BEFORE THE PUBLIC SERVICE COMMISSION OF UTAH

In the Matter of the Application of)	Docket No. 07-035-93
Rocky Mountain Power for Authority to)	
Increase Its Retail Electric Service Rate in)	Surrebuttal Testimony of
Utah and for Approval of Its Proposed)	Randall J. Falkenberg
Electric Service Schedules and Electric)	On Behalf of the
Service Regulations, Consisting of a)	Utah Committee of
General Rate Increase of Approximately)	Consumer Services
\$161.2 Million Per Year, and for Approval)	
Of a New Large Load Surcharge)

May 23, 2008

SURREBUTTAL TESTIMONY OF RANDALL J. FALKENBERG

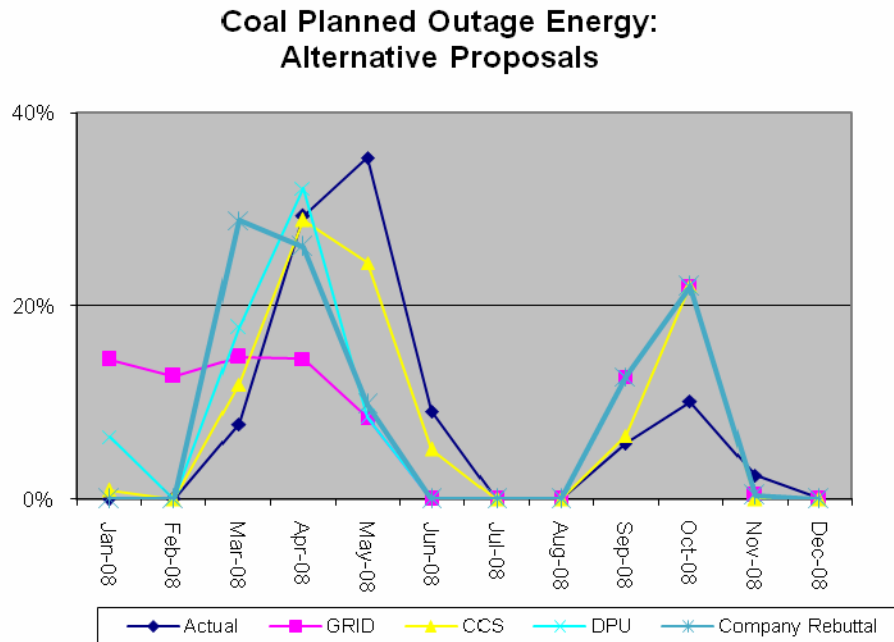
556 **Q. CAN YOU PROVIDE A COMPARISON OF THE COMPETING OUTAGE**
557 **SCHEDULES IN THIS CASE?**

558
559 A. Yes. Figure 1, below compares the various schedules.⁴ As the figure shows, the
560 Company moved outages out of January and February, but most ended up in
561 March and April. Despite evidence of actual practice, the Company still proposes
562 to schedule no planned outage energy in June and very little in May. Historically,
563 May has the most planned outage energy. June is comparable to October, and
564 normally far exceeds September. It appears from Mr. Duvall's schedule, that his
565 primary criteria seems to have been to *avoid* scheduling maintenance in months
566 that have low market prices, which completely ignores the actual history during
567 the four-year period he used to establish the planned outage durations for each
568 resource.
